UNITED STATES
NUCLEAR REGULATORY COMMISSION
WASHINGTON, D. C. 20555

September 21, 1979

SUBJECT: NRC REQUIREMENTS FOR AUXILIARY FEEDWATER SYSTEMS AT POINT BEACH
NUCLEAR PLANT, UNITS 1 AND 2

POINT BEACH 1 AND 2

Auxiliary Feedwater System
Pl. Reach 1 & 2
Figure 1

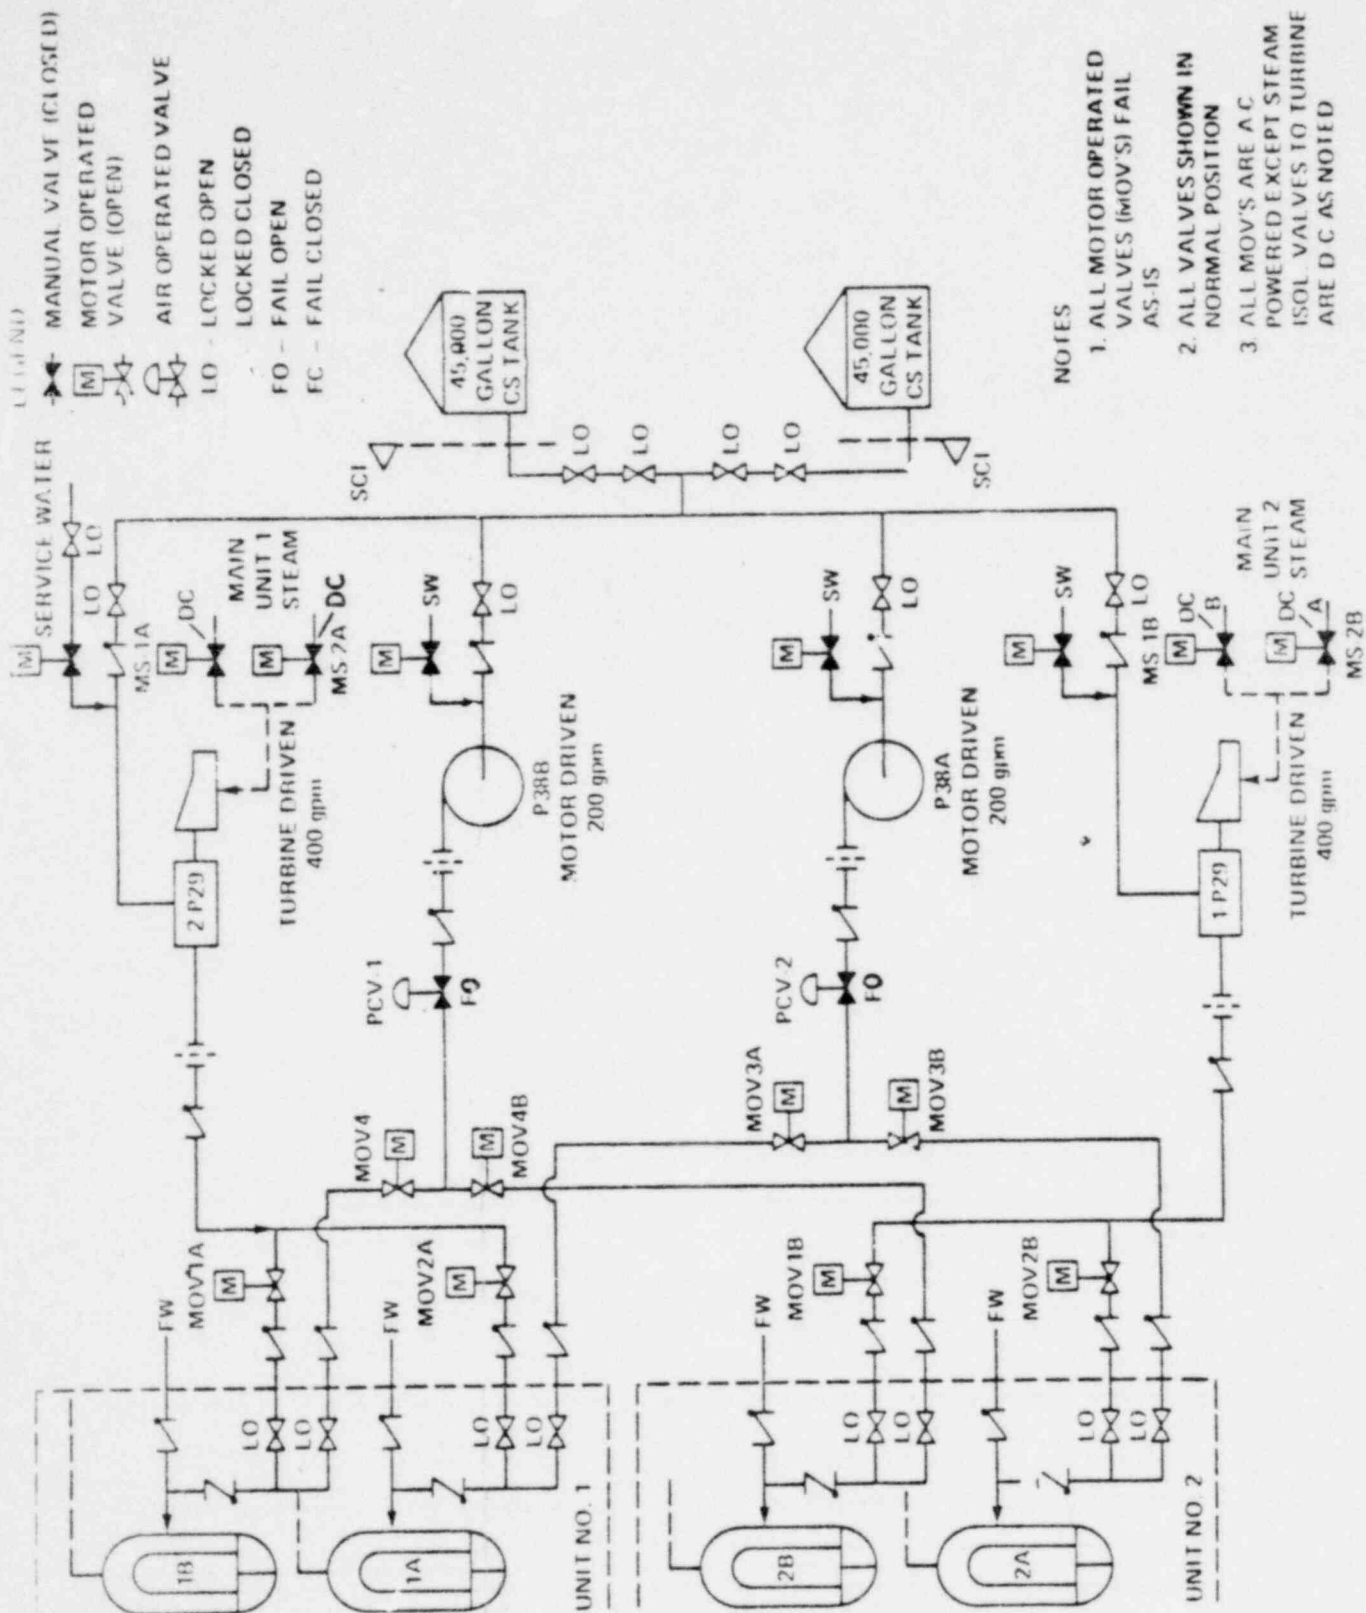
A simplified flow diagram of Point Beach 1 and 2 AFWS is shown in Figure 1. The automatically initiated auxiliary feedwater (AFW) system for each Point Beach Unit is partially shared between units 1 and 2 to supply AFW to both steam generators of each unit. Each AFW system uses a turbine drive pump and a motor driven pump. The turbine driven pump of one unit feeds both steam generators of that unit only. The motor driven pump of each unit feeds one steam generator in each unit and therefore is shared between units. The turbine driven pumps supply AFW to the main feedwater piping inside containment through a motor operated valve for each steam generator of their respective units. The motor operated valves (MOV 1A and 2A for Unit 1, MOV 1B and 2B for Unit 2 on Figure 1) are normally opened to a throttled position to supply design flow to each steam generator. On loss of power these valves fail as-is.

Each of the two motor driven pumps supplies AFW to one steam generator of each unit through individual motor operated isolation valves which are normally open and fail as-is on loss of power. (MOV 3A and 3B from one pump and MOV 4A and 4B from the other pump). A pressure control valve (PCV-1 for Unit 1, PCV-2 for Unit 2) at the discharge

Since all valves in the flow path to the steam generators are normally open and fail as-is (with exception of PCV-1 and 2 which fail open) a loss of A-C or D-C power does not require valve manipulation. The motor operated steam valves at the inlet to the turbines (MS-1A and 2A for Unit 1, MS-1B and 2B for Unit 2) are D-C motor operated valves and will automatically open in the event of a loss of all A-C power.

In the event of an unisolable main steam or feedwater line break coincident with a worst case single active failure, operator action within the control room will isolate AFW flow to the affected steam generator and assure flow to the unaffected steam generator. The licensee estimates >50 minutes to boil dry.

A break anywhere in the auxiliary feedwater system discharge piping would not prevent automatic AFW flow to at least one steam generator on demand. A single active failure coincident with a break could disable automatic AFW to both steam generators, depending on break location. In either case, breaks could be isolated by operator action within the control room.

The dominant failure contributor is loss of both motor-driven pumps and subsequent failure of the turbine driven pump due to loss of service water (AC) cooling to steam turbine pump bearing oil.

The principal noted dependency is the design for AC cooling of the turbine driven pumps.

1. Recommendation GS-1 - The licensee should propose modifications to the Technical Specifications to limit the time that one AFW system pump and its associated flow train and essential instrumentation can be inoperable. The outage time limit and subsequent action time should be as required in current Standard Technical Specifications; i.e., 72 hours and 12 hours, respectively.

2. Recommendation GS-2 - The licensee should lock open single valves or multiple valves in series in the AFW system pump suction piping and lock open other single valves or multiple valves in series at could interrupt all AFW flow. Monthly inspections should be performed to verify that these valves are locked and in the open position. These inspections should be proposed for incorporation into the surveillance requirements of the plant Technical Specifications. See Recommendation GL-2 for the longer-term resolution of this concern.

Recommendation GS-5 - The as-built plant should be capable of providing the required AFW flow for at least two hours from one AFW pump train independent of any alternating current power source. If manual AFW system initiation or flow control is required following a complete loss of alternating current power, emergency procedures should be established for manually initiating and controlling the system under these conditions. Since the water for cooling of the lube oil for the turbine-driven pump bearings may be dependent on alternating current power, design or procedural changes shall be made to eliminate this dependency as soon as practicable. Until this is done, the emergency procedures should provide for an individual to be stationed at the turbine-driven pump in the event of the loss of all alternating current power to monitor pump bearing and/or lube oil temperatures. If necessary, this operator would operate the

1. Recommendation GL-3 - At least one AFW system pump and its associated flow path and essential instrumentation should automatically initiate AFW system flow and be capable of being operated independently of any alternating current power source for at least two hours. Conversion of direct current power to alternating current is acceptable.

3. Recommendation-GL-5 - The licensee should upgrade the AFW system automatic initiation signals and circuits to meet safety-grade requirements.
